UNITED STATES PATENT AND TRADEMARK OFFICE

APPLICATION NO.	FILING DATE	FIRST NAMED INVENTOR	ATTORNEY DOCKET NO.	CONFIRMATION NO.
10/743,149	12/23/2003	Susuma Tanaka	0229-0787P	7468

Office Action Summary	Application No. 10/743,149	Applicant(s) TANAKA, SUSUMA	
	Examiner Steven D. Maki	Art Unit 1733

FIG. 9(A)

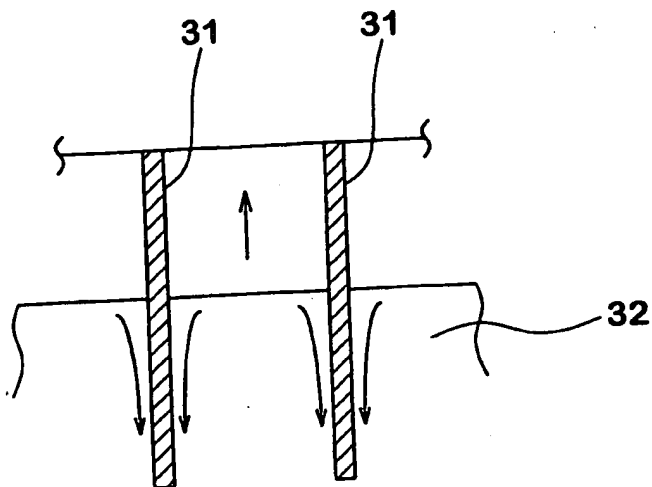
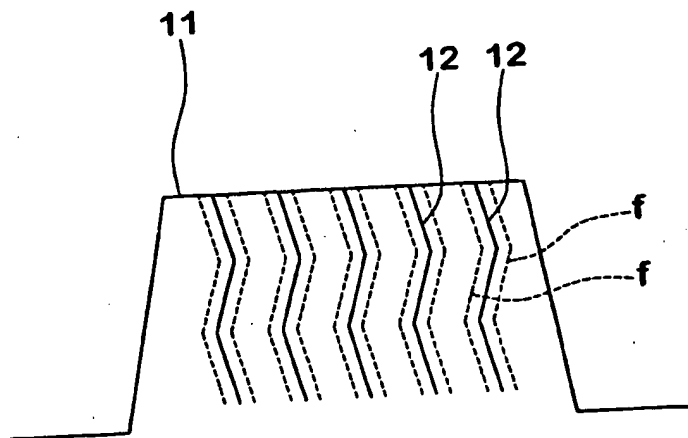
SM approved
and
accepted
4-11-06

FIG.10(A)
PRIOR ART

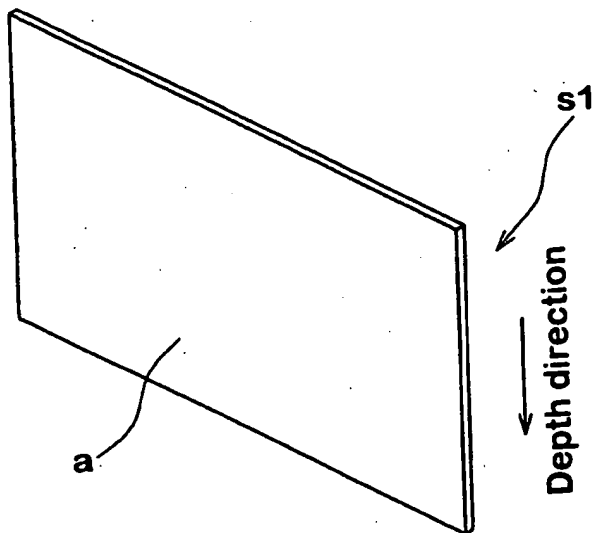
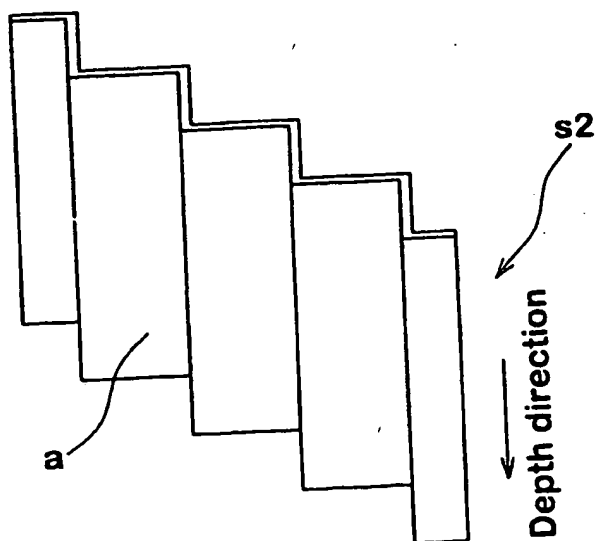
approved
and
accepted
